Application of Vipin Bhimji c/o Battle Law, P.C. to rezone property from R-100 (Residential Medium Lot-100) zoning district to RSM (Small Lot Residential Mix) zoning district to allow the development of single-family homes, at 3430 N. Druid Hills Road.

PETITION NO: N4-2026-1263 Z-26-1248243

STAFF ANALYSIS

CASE NO.:	Z-26-1248243	File ID #: 2026-1263
Address:	3430 N Druid Hills Road, Decatur, GA 30033	Commission Districts: 2 and 6
Parcel ID(s):	18 113 12 001	
Request:	Application of Vipin Bhimji c/o Battle Law, P.C. to rezone property from R-100 (Residential Medium Lot-100) zoning district to RSM (Small Lot Residential Mix) zoning district to allow for the development of single-family homes.	
Property Owner(s):	Vipin Bhimji	
Applicant/Agent:	Vipin Bhimji c/o Battle Law P.C	
Acreage:	1.39	
Existing Land Use:	Vacant lot	
Surrounding Properties:	Mix of detached and attached residential developments.	
Adjacent Zoning:	North: RSM (Residential Small Mix) South: R-75 (Residential Small Lot-75), MR-2 (Medium Residential Density-2) East: R-75 West: RSM, MR-2	
Comprehensive Plan:	Suburban - Consistent X

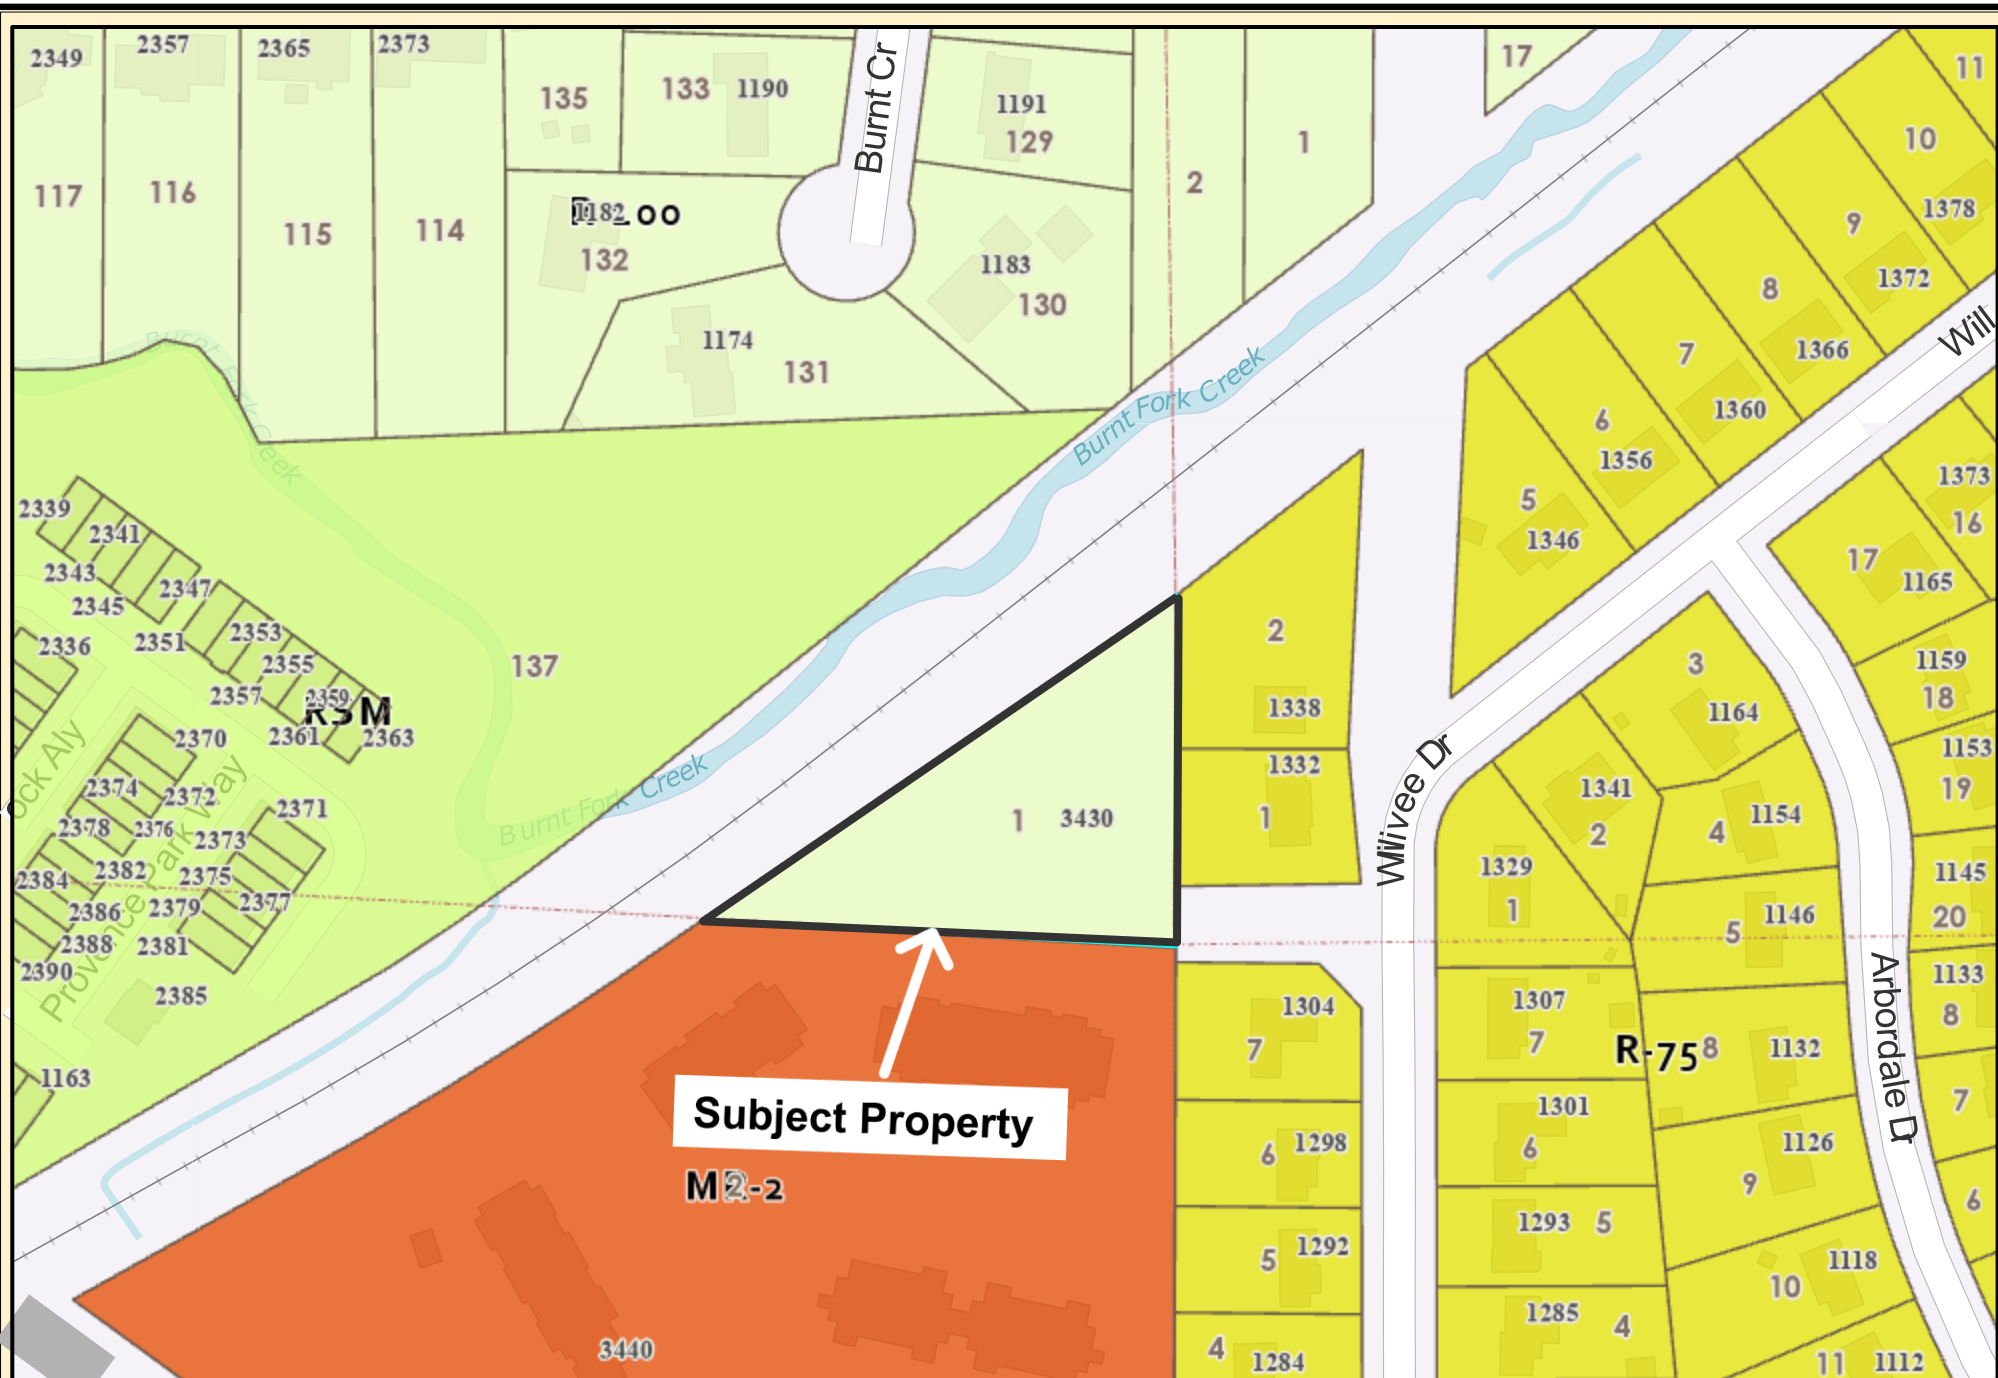
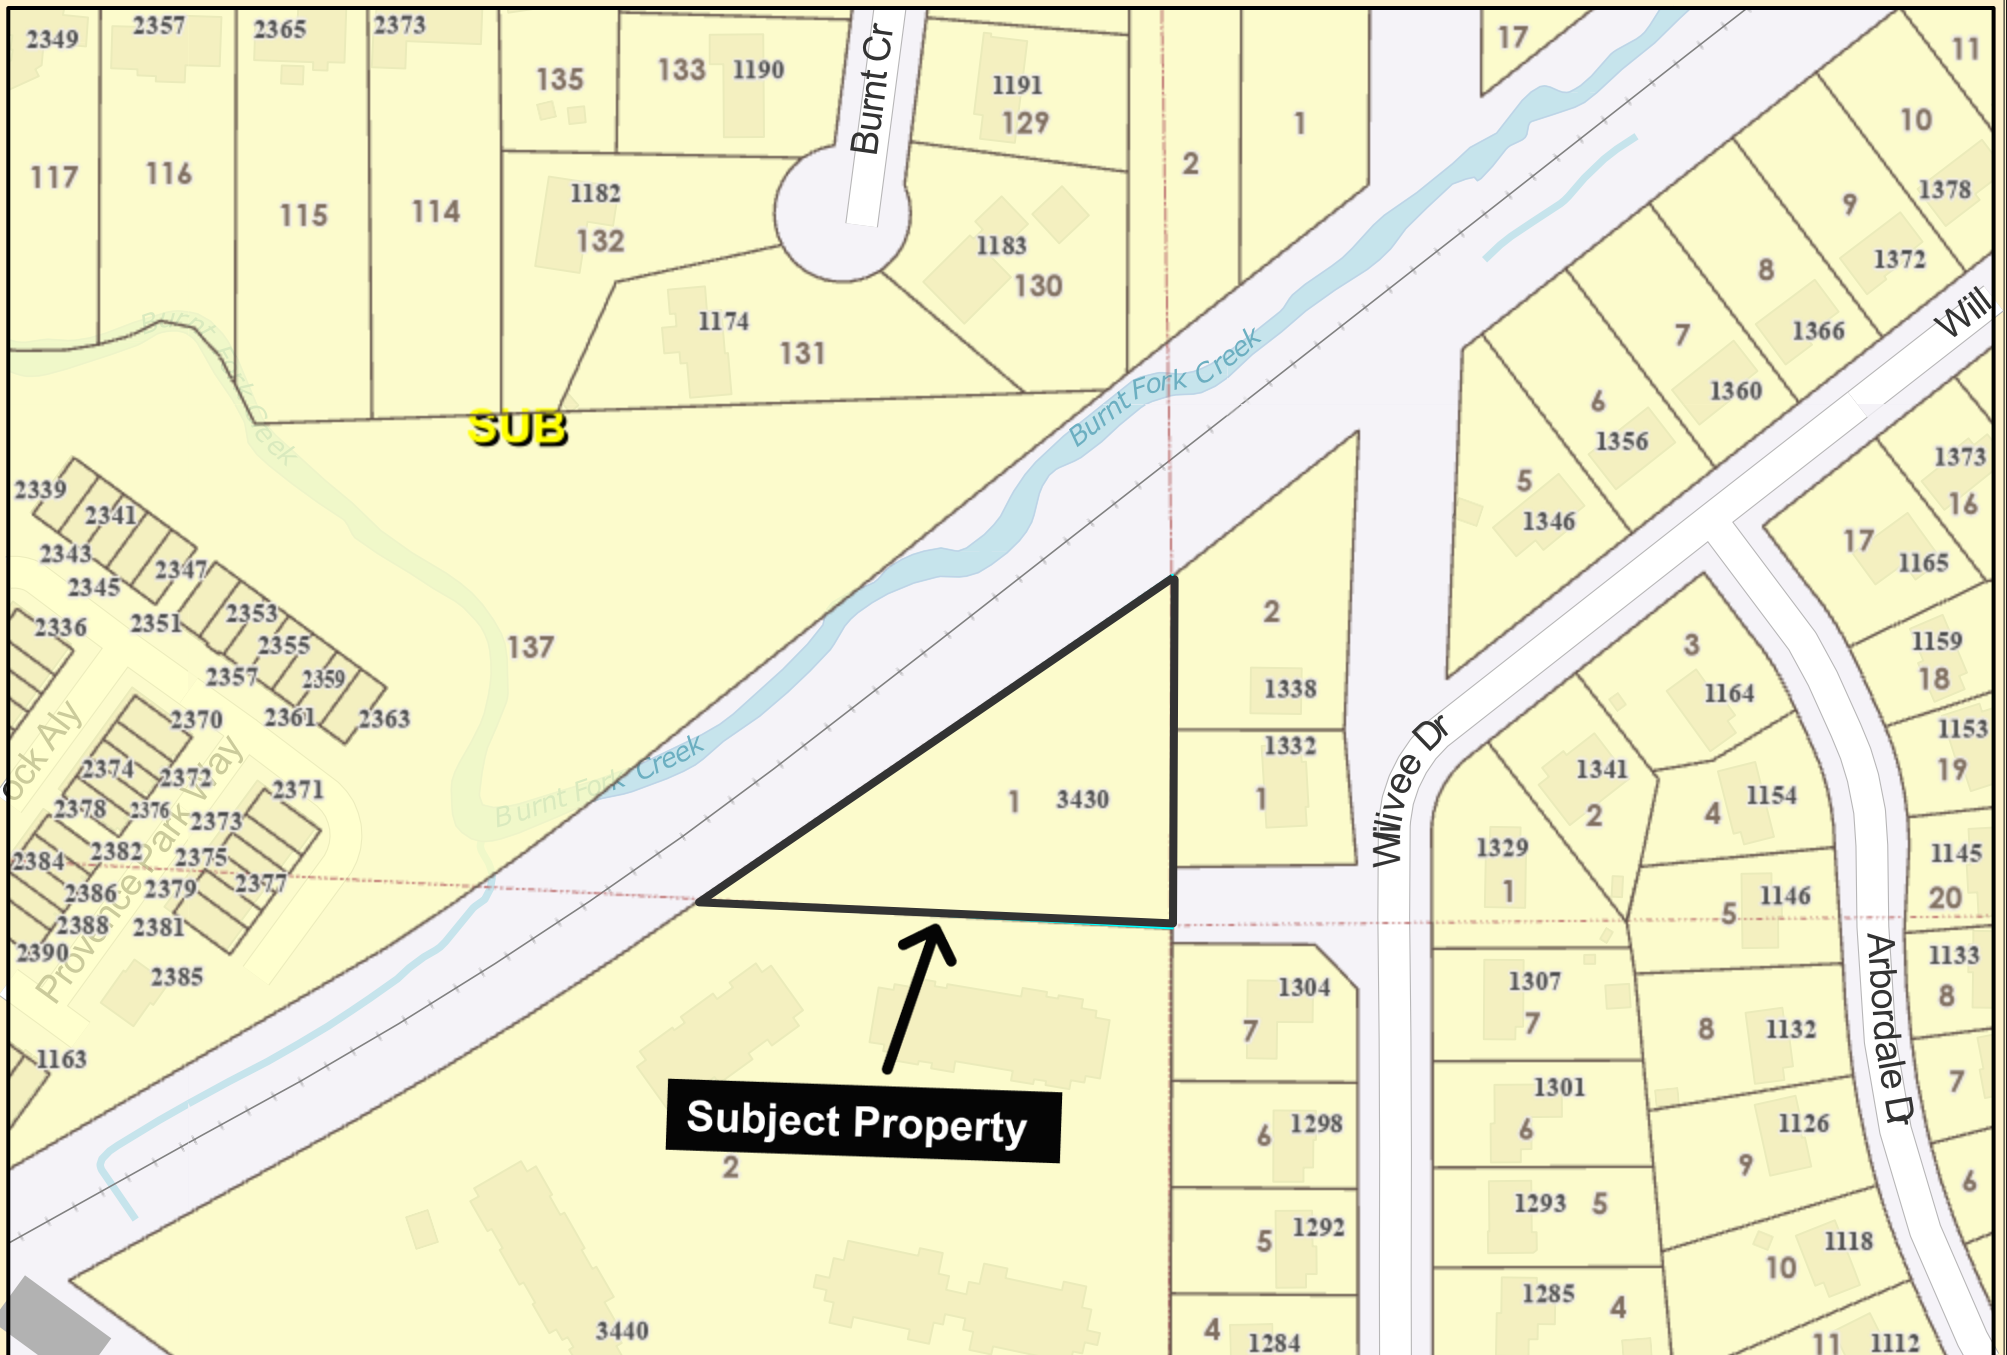
Comments: Must meet SUB character area - Max 4 units per acre base up to 8 with density bonuses.

Looks like there may be floodplain encroachments on north side of property.

Comply with Article 5, relating to street trees, sidewalks, etc....

Must show compliance with RSM zoning requirements including but not limited to min building setback
max building height, building materials, parking, etc. Stub out streets are not allowed/discouraged.
